Project	IEEE 802.16 Broadband Wireless Access Working Group	
Title	Functional Requirements for the 802.16.3 Interoperability Standard	
Date Submitted	2000-04-29	
Source	Brian Petry (editor) 3Com 12230 World Trade Dr. San Diego, CA 92128	Voice: (858) 674-8533 Fax: E-mail:brian_petry@3com.com
Re:	<p>This is a collaborative effort by the 802.16.3 Functional Requirements Task Group which started from a contribution by George Fishel and was further revised by the task group by a formal comment/resolution process. Please be sure you are reading the most recent published version of this document (802.16.3-00/02rx where x is the version number) which can be found at: http://ieee802.org/16/sub11/docs/802163-00_02.pdf</p> <p>This document is input to 802.16 session #7 (1-5 May, 2000). It contains edits that will be reviewed by the 802.16.3 task group at session #7.</p>	
Abstract	<p>This document provides functional requirements that are guidelines for developing an interoperable 802.16.3 air interface. The 802.16.3 committee desired to reach an understanding and consensus for functional requirements before proceeding with developing standards for 802.16.3 MAC and PHY protocols and thus forme

Figure 2-2: System Reference Points [E; Goldhammer: change "voice data and video" to "data voice video"] [T; Freedman: Add optional Central Control Station and more base station to diagram] [T; Trinkwon: Amend Figure 2-2 to show :

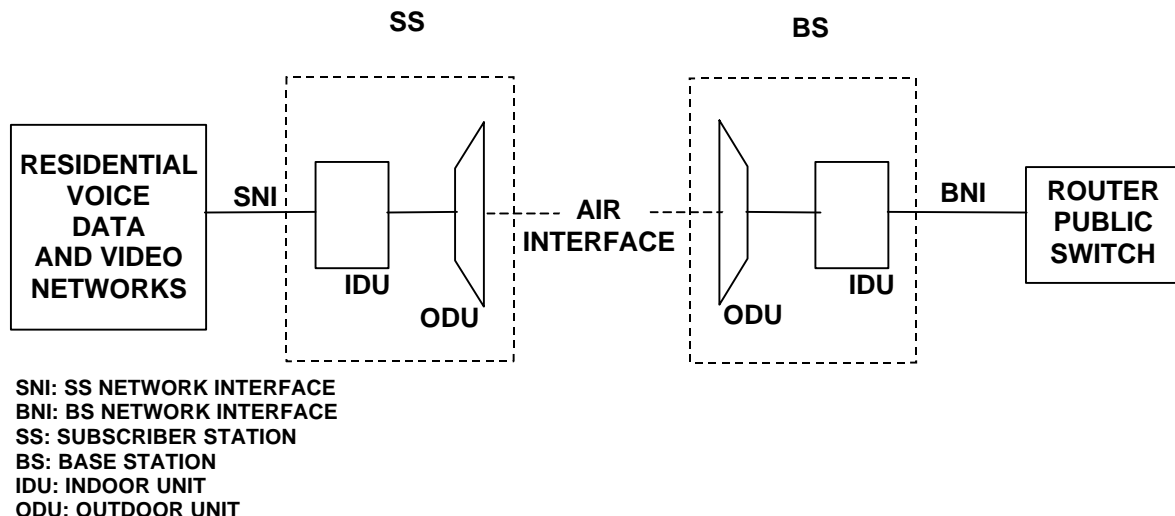
1 a) Local Power within the SS box, supplying the IDU and ODU.

2 b) Multiple ODU's per IDU at the BS

3 c) Remote IDU's from the BS IDU. These Remote units / antenna would be located
 4 away from the BS site to improve coverage / economics in range or capacity limited
 5 deployments.

6
 7 d) The BS IDU might not be located at the BS - it might be at another location (which
 8 might be the same as the public switch / router)

9
 10 e) The switch / router might not be public - it might be a private / corporate edge device
 11 which might, or might not have public network gateways / connections behind it.

12 [T; Kasslin: In Figure 2-2 delete the drawings inside the SS and BS boxes
 13 and delete the terms IDU and ODU.]

14
 15 [T; Wachira: Remove references to ODU and IDU]
